**Regular Council - Land Use**  
**Item B.9: 7919-0245-00**  
**Monday, May 31, 2021**  
**Supplemental Information - Page Replacements**

RE: **Item B.9 - May 31, 2021 Regular Council Land Use Agenda**  
**Replacement Appendix**  
**Development Application No. 79 19-0245-00**

**Re: Response to Advisory Design Panel Comments from October 29, 2020 Presentation**  
**10466 – 10516 – 140B Street**

**ROOF EQUIPMENT SCREEN DETAIL**  
SCALE: N.T.S. INSTALLED TO MANUFACTURER'S SPECS

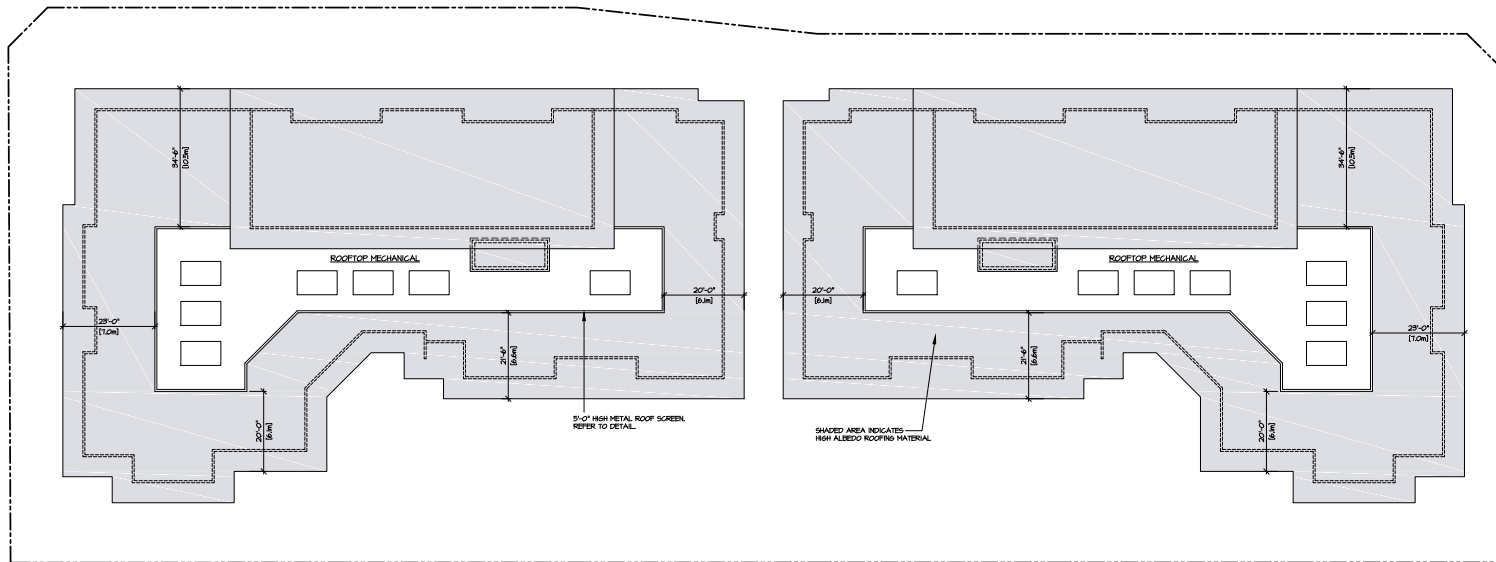
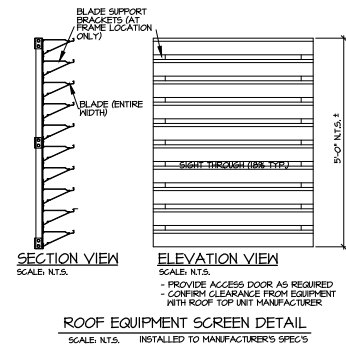
- Providing screening if mechanical equipment is installed on rooftop.  
Rooftop mechanical equipment is proposed. A screening detail is provided on the roof plan included with the latest submission.
